BEFORE THE BOARD OF PATENT APPEALS
AND INTERFERENCES

Application Number: 10/051,577
Filing Date: January 16, 2002
Appellant(s): RATHERT, HORST

EXAMINER'S ANSWER

Problem B – As seen in figure 2;

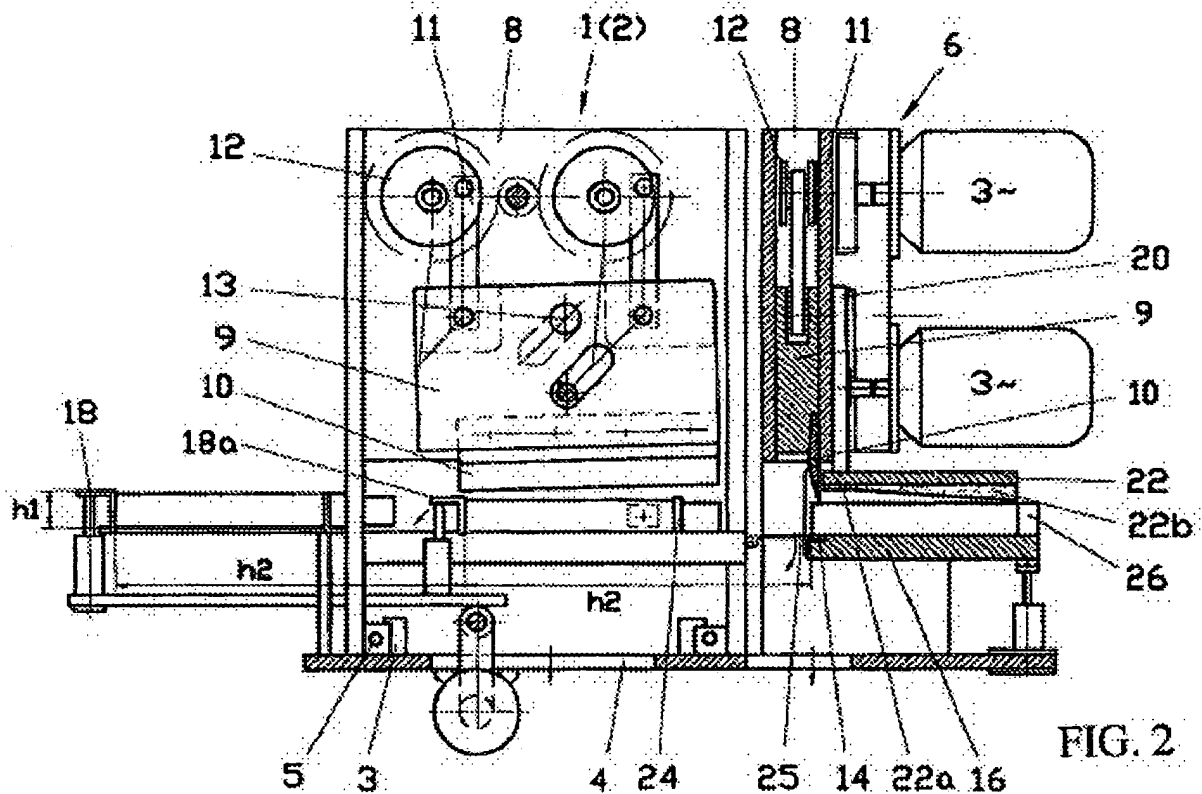
Problem A – Line 11 of page 4 recites that “*All pressing and cutting forces remain within the compact units*”. However, claim 2 recites that “*the support frame is loaded only by the weights and dynamic forces of said cutting units*”. Since the “pressing and cutting forces” are undoubtedly “dynamic forces”, there is a conflict as to whether or not these some of these forces are passed onto the support frame. Is blade movement initiation and it’s reactionary forces part of the “dynamic forces” or parting of the “cutting forces”?

Each cutting unit has three motors; two on top to drive the blade and one on bottom to drive the clamp. The two motors on top drive eccentrically mounted links (11) that would create a wobbling reactionary force that would be transmitted to the support frame. The bottom motor drives a laterally offset rack (20), which would create a reactionary torque that would be transmitted to the support frame. The blade (9) moves diagonally and the rack (20) moves vertically and would create reactionary diagonal and vertical forces that would be transmitted to the support frame. The blades and clamps impact the workpiece in a downward direction, which is a force that would be

transmitted to the support frame. So there are at least 6 unique forces that are “dynamic forces” or “pressing and cutting forces” that are transmitted to the support frame, which begs the question of “how are the cutting units *closed in themselves*”.

One of ordinary skill could arguably be aware of ways to minimize simple reactionary forces by employing counterbalances of some sort (e.g. a “recoilless rifle”). But in this case, there are so many forces working in so many directions that it is not at all clear how one would avoid transmitting forces to the support frame, even assuming one could solve problem A first and know which forces had to be stopped. Even if the forces in question are just the impact of the blade and pressing strip onto the book, then it is still not obvious how to not pass those forces on to the support frame below. This is an especially tricky problem because different books being trimmed have different thicknesses, and thus the knife and clamp will impact at different times depending on the book thickness, and thus and knife-and-clamp-impact force compensator would have to have some complex mechanism to take this into account in order to substantially counterbalance the downward force for different book thicknesses.
